### **Summary of Changes**

#### **Turkey Point Plant Radiological Emergency Plan , Revision 43**

**TURKEY POINT PLANT**  
**RADIOLOGICAL**  
**EMERGENCY PLAN**  
**REVISION 43**

Revision Approval Date: 10 / 4 / 05

FIGURE 5-1 (1 of 3)

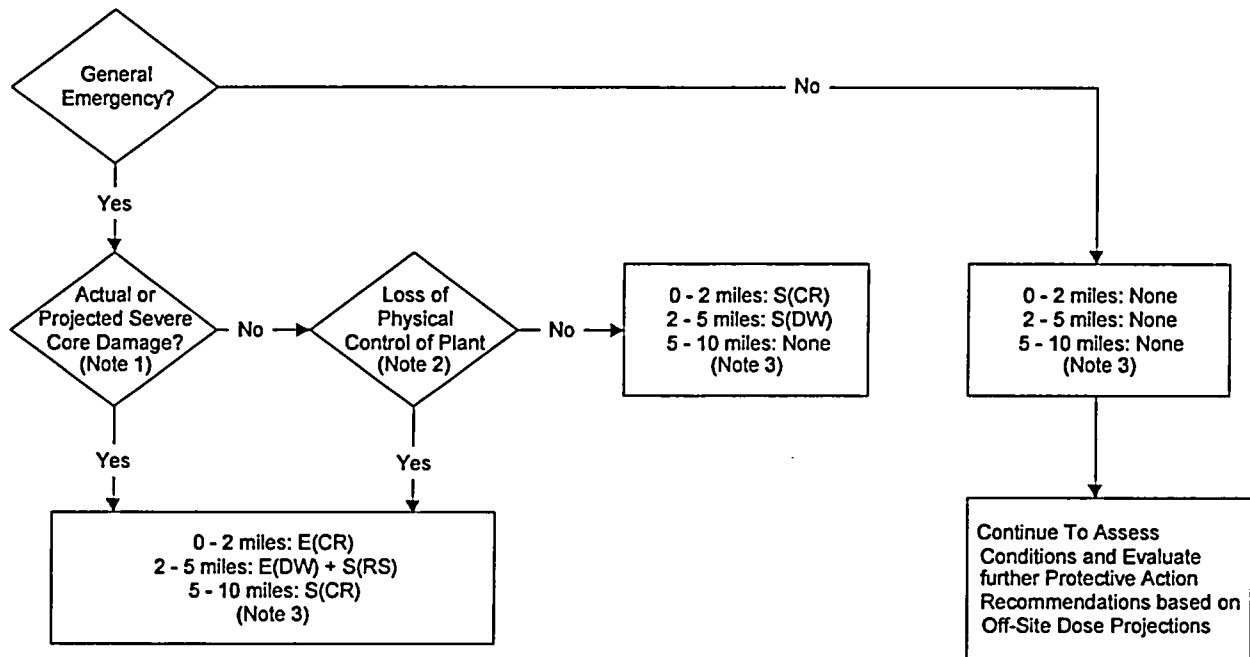
1. Revised the guidance for determining Protective Action Recommendations resulting from a radiological release lasting less than 2 hours as described in NRC RIS 2001-13, Consideration of Sheltering in Licensee's Range of PARs.
2. Updated Letters of Agreement with various offsite support agencies.
